A review of the HumeLink Project Assessment Conclusions Report

VEPC WP2109
September 2021

A review of the HumeLink Project Assessment Conclusions Report¹

¹ [Project Assessment Conclusions Report](#) "Reinforcing the NSW Southern Shared Network to increase transfer capacity to demand centres (HumeLink)", TransGrid, 29 July 2021.

Figure 2 The options presented geographically, showing individual circuits

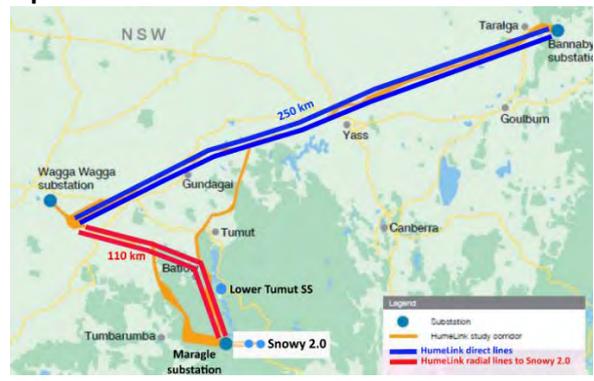
The schematic representations in Figure 1 don't indicate the routing features of the options. Accordingly, Figure 2 has been prepared to provide an indicative geographical representation.

The PACR is quite confusing on the route for Option 3C, so Figure 2 presents it in two forms – 3C-1 reflects the schematic representation in Figure 1, whilst 3C represents what is thought to be the physical representation. The three colours represent the three legs of the HumeLink 'triangle'.

Figure 2 also introduces Options 2L and 3L, moving the Snowy 2.0 connection point to the existing Lower Tumut Switching Station (LTSS), as recommended in this paper, rather than the proposed new substation at Maragle.

However, there is confusion on the physical construction of Option 3C with double-circuit lines in light of the schematic representation in Figure 1 of a triangular arrangement. This paper assumes what is proposed is reflected in Figure 2, showing a Y arrangement, made up of double-circuit lines.

Figure 4 Estimated net benefits weighted, excluding competition benefits, (PACR Figure 26)

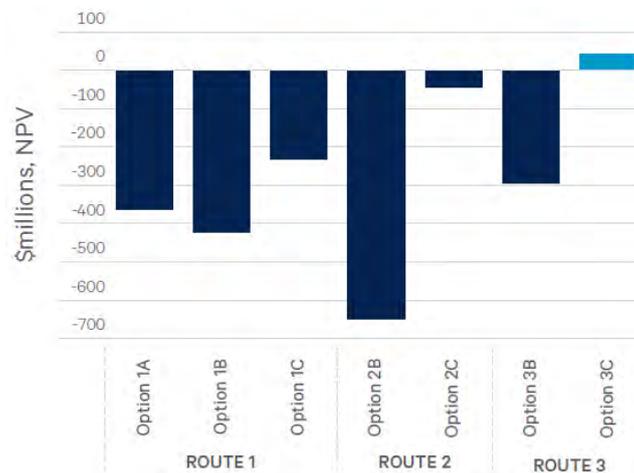
In the first stage, before accounting for competition benefits, only Option 3C had a positive net benefit of just \$39m. Option 2C is next with minus \$44m and then Option 1C with minus \$220m (Figure 4).

“On a weighted-basis, Option 3C is the top-ranked option and is expected to deliver approximately \$39 million in net benefits (excluding competition benefits), which is around \$83 million more net benefits than the second-ranked option (Option 2C) in present value terms.”

Figure 5 AEMO 2021 Transmission Cost Report (information from TransGrid)

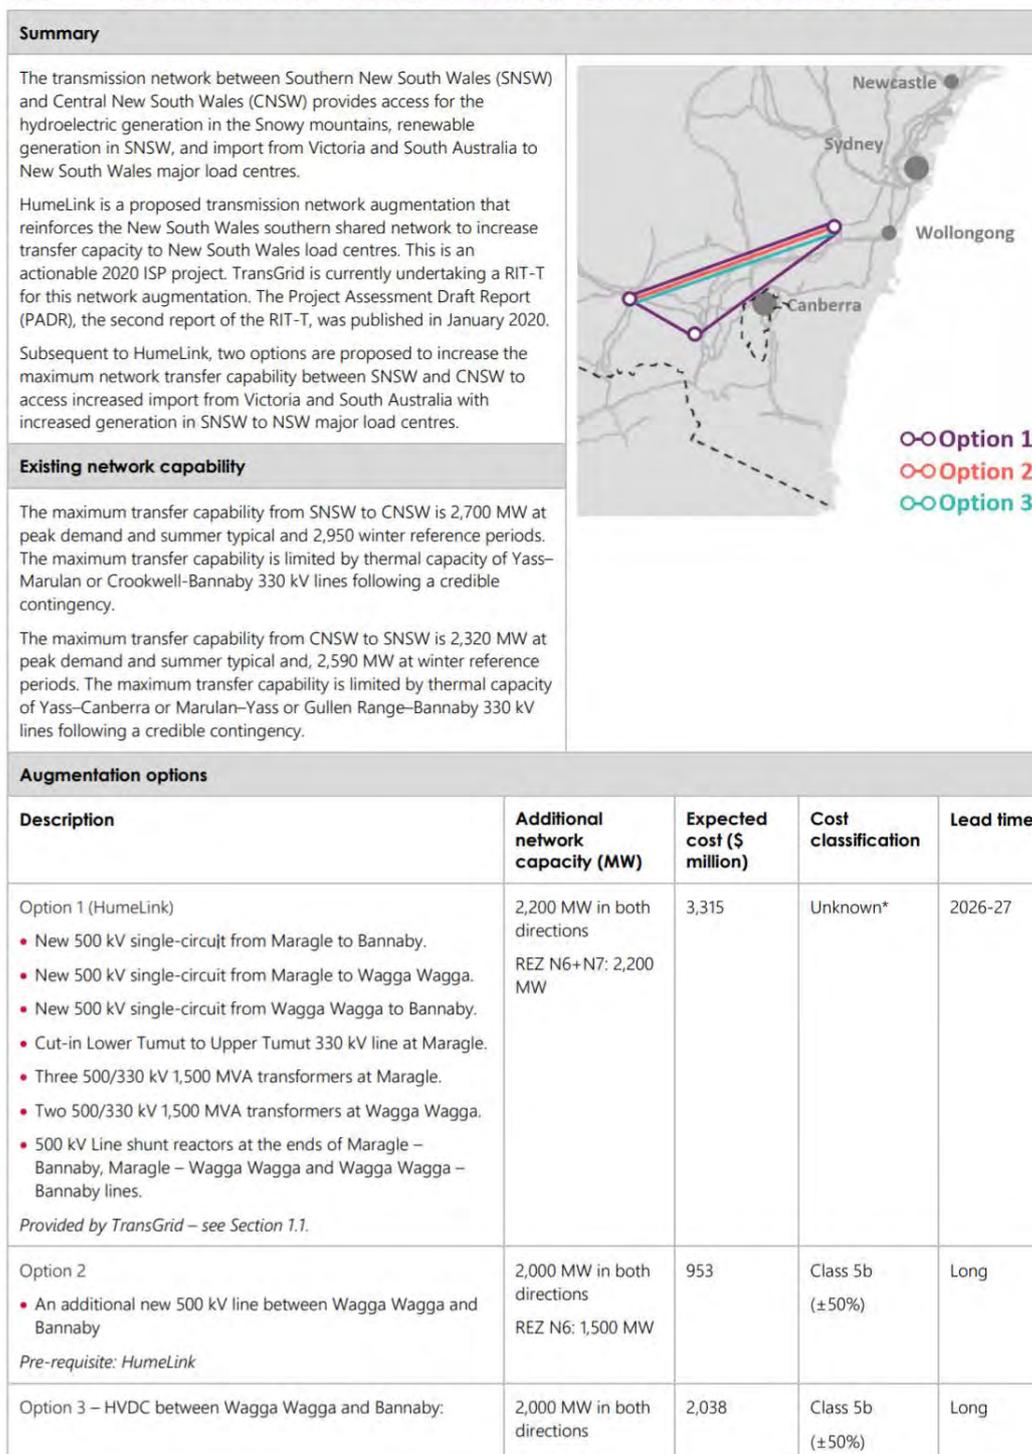
To add to the confusion, the [AEMO Transmission Cost Report, Aug 2021](#) was issued after the PACR indicating three single-circuit 500 kV lines between Bannaby, Wagga Wagga and Maragle at a cost of \$3,315m, based on information provided by TransGrid (Figure 5).

The PACR Option 3C schematic in the AEMO report (identified there as Option 1) also repeats the confusing PACR triangular routing schematic in Figure 1.

It is also noted there is a 370 MW anomaly between the PACR estimate of HumeLink’s capacity of 2,570 MW and the information provided by TransGrid to AEMO of 2,200 MW (Figure 5). It is assumed that the PACR estimate is the correct one.

Figure 10 Connecting to LTSS rather than Maragle (Option 2L)

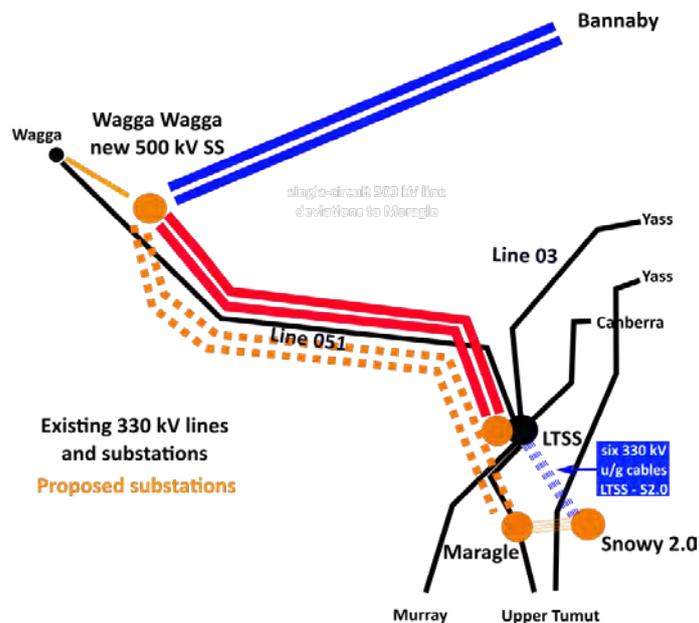
Figure 10 shows the LTSS hub, with the five existing 330 kV connections, to Murray, Upper Tumut, Canberra, Yass and Wagga Wagga, and the two 500 kV HumeLink connections for Option 2L.

The existing Line 051 could be ‘replaced’ with a 500 kV double-circuit line for its full length to the new Wagga Wagga 500 kV substation, as could Line 03 to Yass for Option 3L (see later).

Figure 11 Option 3LX

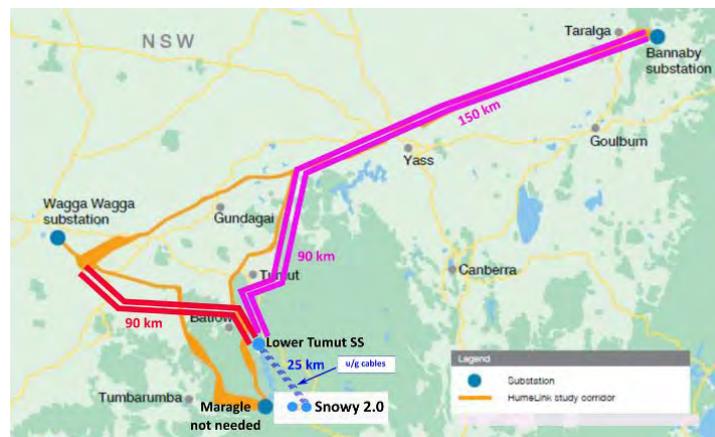
This paper suggests consideration of another option which is a variation of Option 3L, termed 3LX (Figure 11).

Figure 12 Southern NSW Network ([TransGrid 2021 Planning Report Fig 2.16](#))

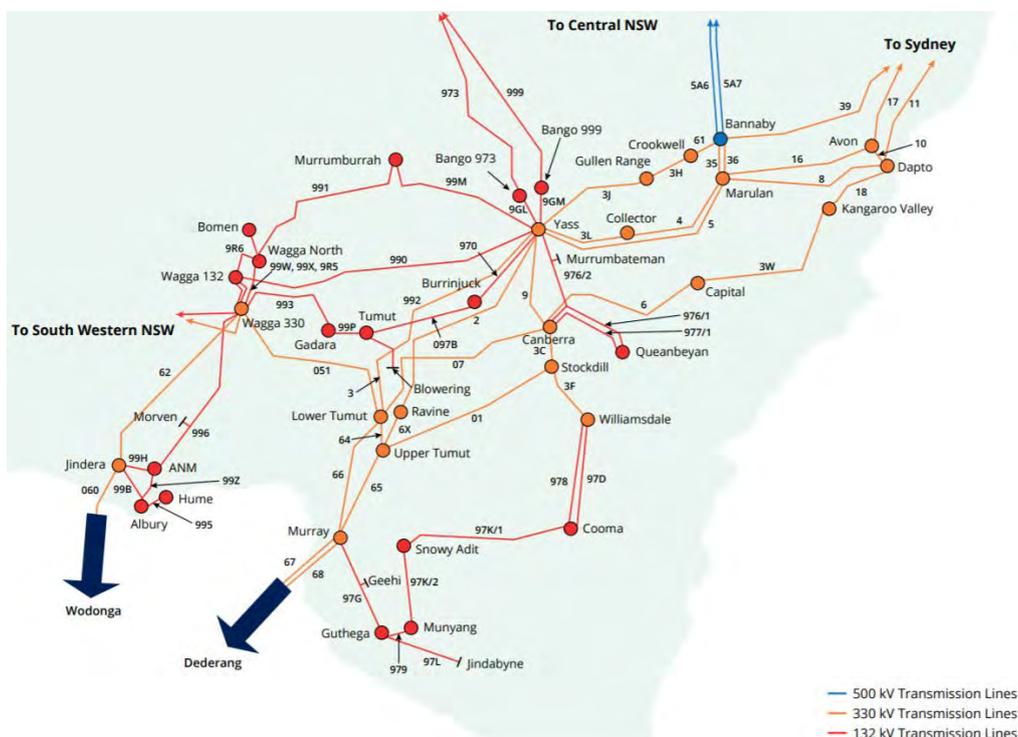
Figure 12 shows the southern NSW network. Consideration should be given to using the easements for the 330 kV lines from LTSS to Wagga Wagga (Line 051), from LTSS to Yass (Line 03), and from Yass to Bannaby (direct or via Marulan).

Figure 3: Forecast cumulative gross market benefit^{31,32} for Option 3C under the Central scenario (excluding competition benefits), millions real June 2019 dollars discounted to June 2021 dollars

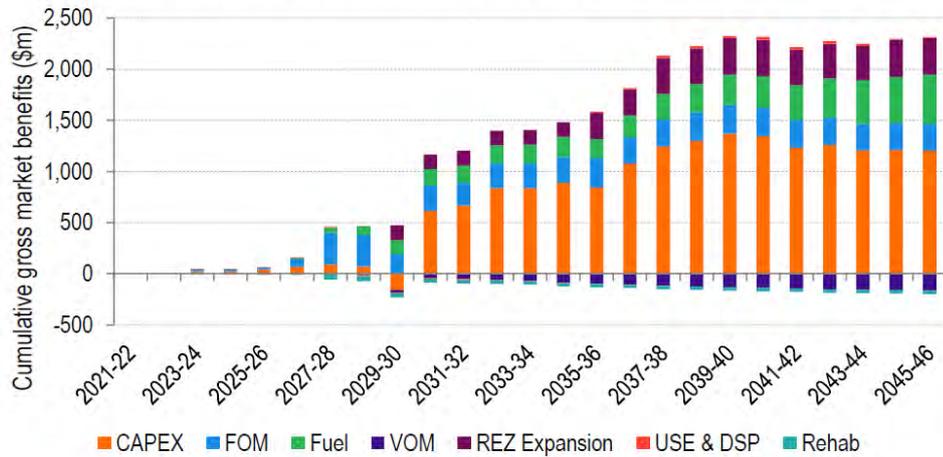
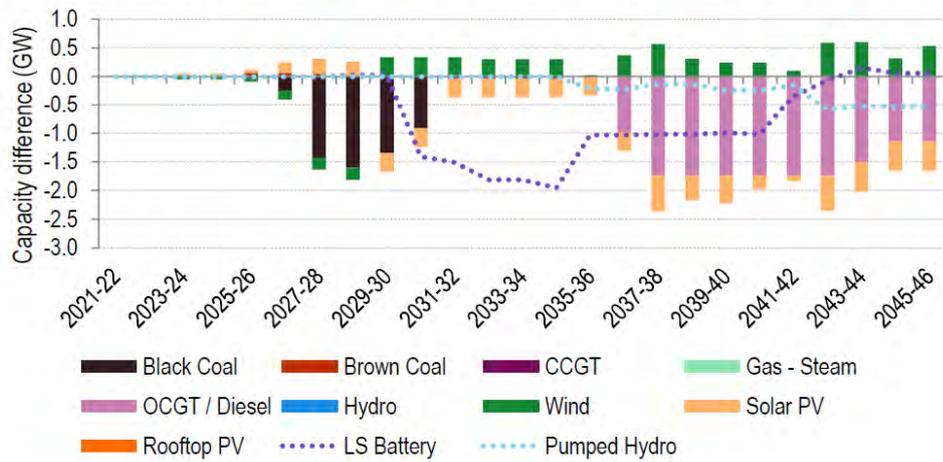
Figures 3 & 4 show cumulative benefits for Option 3C and capacity differences compared to the base case for the Central Scenario. From Figure 3, most of the market benefits are expected to come from displaced Capex. From Figure 4, Option 3C is credited with bringing forward black coal retirements by a few years, deferring LS Battery investment for many

Figure 21: Annual capacity factor for Snowy 2.0 generator and pump for the Base case in all scenarios

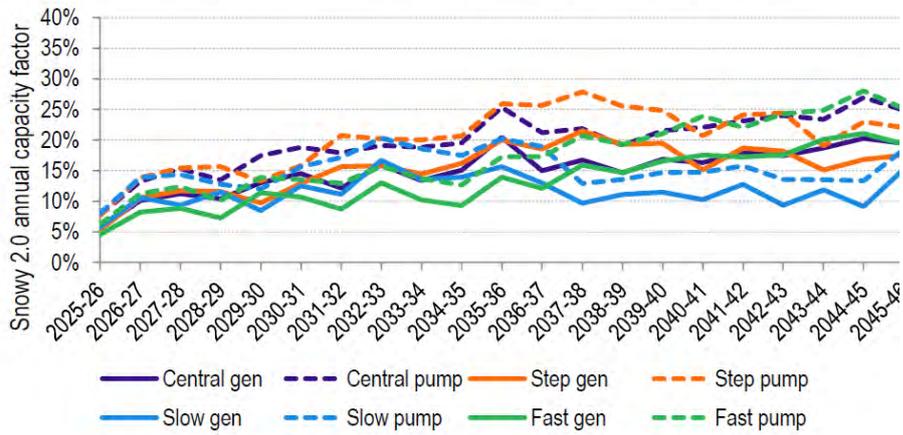
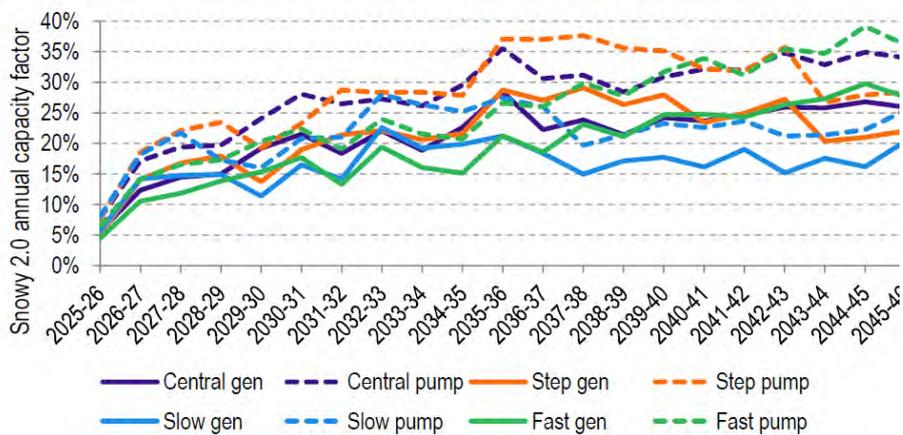
29-30	<p>EY Figures 21 & 22 compare Snowy 2.0 operation (generation & pumping) for all scenarios in the Base Case configuration and the HumeLink Option 3C augmentation configuration. Figure 21 shows that the EY model predicts that, in the Base Case configuration, Snowy 2.0 would operate without HumeLink, reaching highest capacity factors of 27% pumping and 20% generation in the Central Scenario. Note that MJA estimated Snowy 2.0's capacity factor to be ~22% (MJA Figure 30, p 82). Pumping would not compete with existing Snowy generation. If existing Snowy generation was constrained by inflow constraints, upper reservoir issues or downstream release constraints, Snowy 2.0 pumping, if sufficiently cheap, would allow Snowy Hydro to obtain more commercial value from Snowy 2.0 generation at other times. However, whether that would be profitable is another matter. In the HumeLink Option 3C augmentation configuration, EY expects Snowy 2.0 to reach highest capacity factors of 35% pumping and 27% generation in the Central Scenario. Note that Figures 21 & 22 indicate that EY simulated round trip losses for Snowy 2.0 at about 25-27%.</p>

30	<p><i>"Snowy 2.0 operation increases on average around 6.5% in the Central, Step and Fast Change scenarios, and 5.3% in Slow Change."</i> The additional 6.5% capacity factor is effectively the EY estimate of additional operational activity for Snowy 2.0 due to HumeLink.</p>
